# CORPORATION OF THE TOWNSHIP OF ESQUIMALT

### REQUEST FOR DECISION

Report No. DEV-22-091

Development Variance Permit & Development Permit - 856 & 858 Esquimalt Road

**Figure 1.**

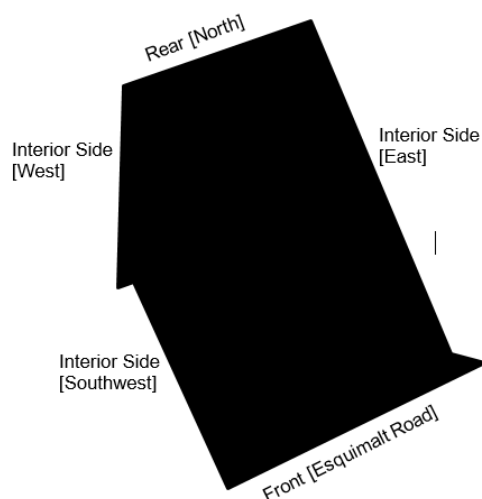
Within this CD-80 Zone, lot lines and setbacks shall be determined in accordance with Figure 1 (below).

(a) Principal Buildings

- (i) No Building shall be located within 7.1 metres of the Front [Esquimalt Road] Lot Line.
- (ii) The northwest wing of the southern Principal Building [Building A] shall not be located within 4.3 metres of the Interior Side [West] Lot Line.

- (iii) The southwest corner of the southern Principal Building [Building A] shall not be located within 3.1 metres of the Interior Side [Southwest] Lot Line.

- (iv) The western wing of the southern Principal Building [Building A] shall not be located within 11.9 metres of the Interior Side [East] Lot Line.
- (v) No Building shall be located within 7.5 metres of the Rear [North] Lot Line.

- (vi) The northern Principal Building [Building B] shall not be located within 7.7 metres of the Interior Side [East] Lot Line.
- (vii) The northern Principal Building [Building B] shall not be located within 6.4 metres of the Interior Side [West] Lot Line.

- (viii) The separation between the east wing of the southern Principal Building [Building A] and the south wing of the northern Principal Building [Building B] shall not be less than 17.5 metres.

- (ix) The separation between the northwest wing of the southern Principal Building [Building A] and the west wing of the northern Principal Building [Building B] shall not be less than 12.5 metres.

- (x) The separation between the northwestern wing of the southern Principal Building [Building A] and the south wing of the northern Principal Building [Building B] shall not be less than 20.0 metres.
